AMENDMENTS TO THE DRAWINGS

Title: FLOWCHART-BASED CONTROL SYSTEM INCLUDING
AUTOMATIC DOWNTIME AND CYCLE TIME ANALYSIS

Atty. Ref. No.: 7287-000012

Figure 1

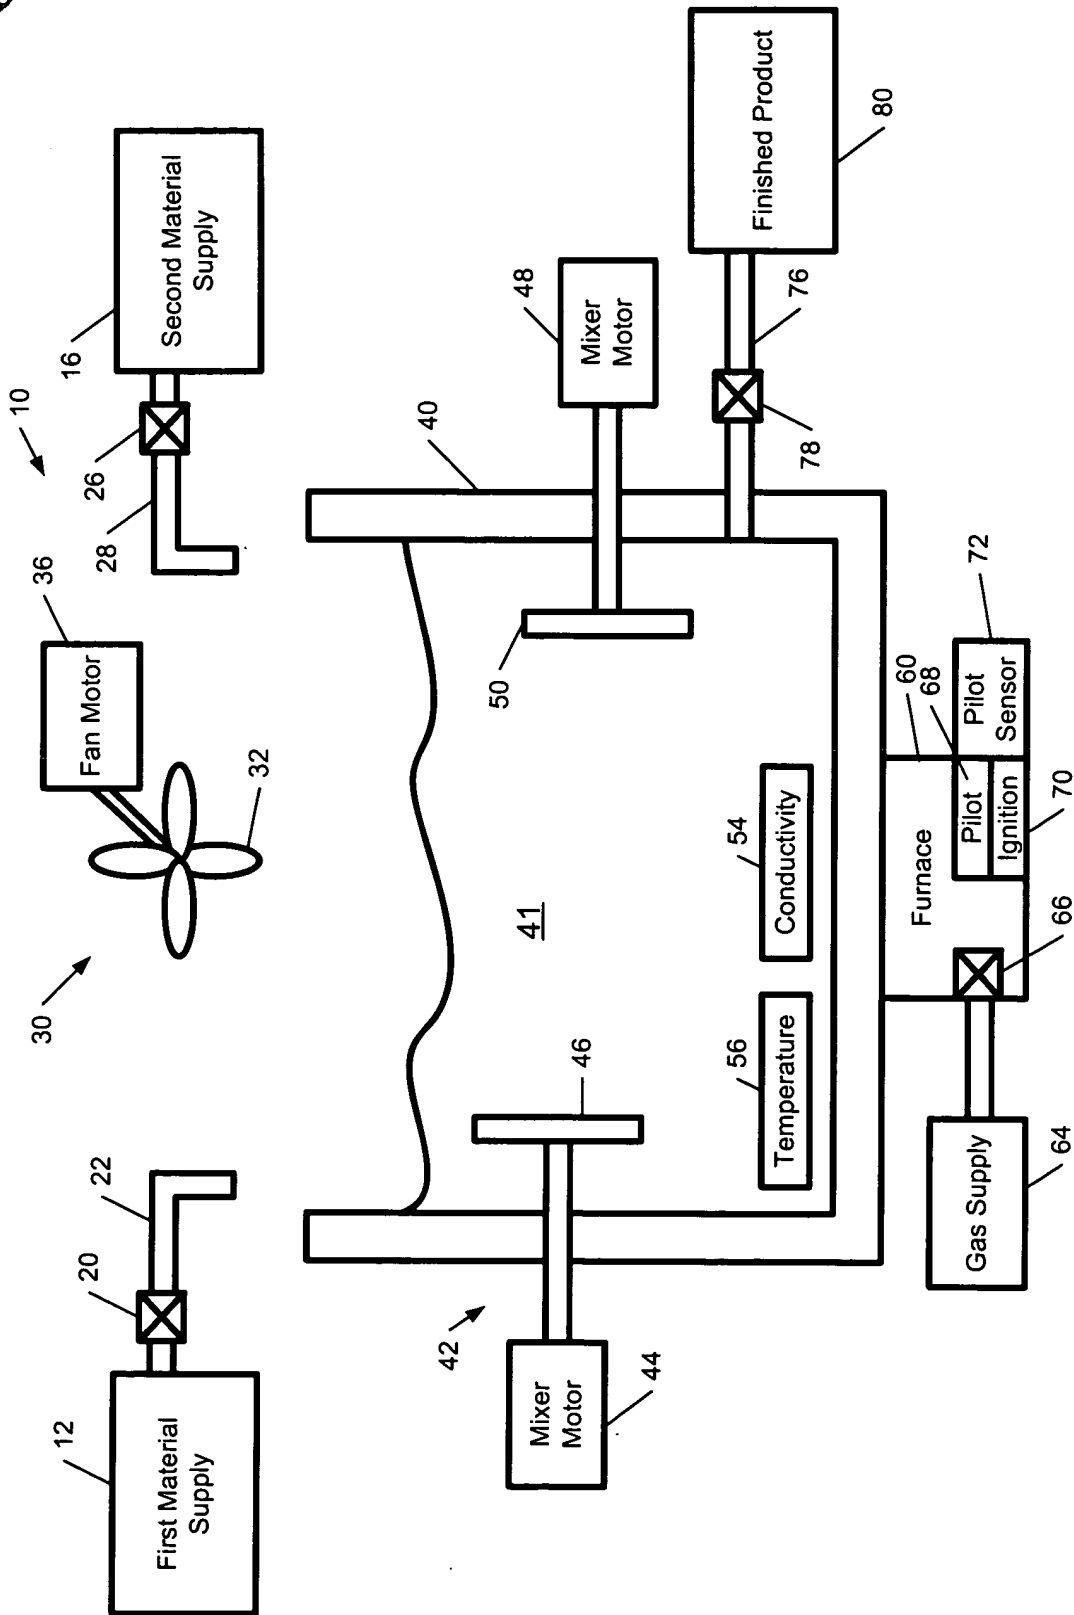
In Figure 1, the arrow 46 has been deleted. In Figure 2, the reference number 150 has been changed to 176. In Figure 3A, the reference number 142 has been changed to 60. In Figure 4, the reference number 224, associated with "Remove" box, has been changed to 226. In Figure 4, the reference numbers 235-1 has been changed to 235-2 and 235-3.
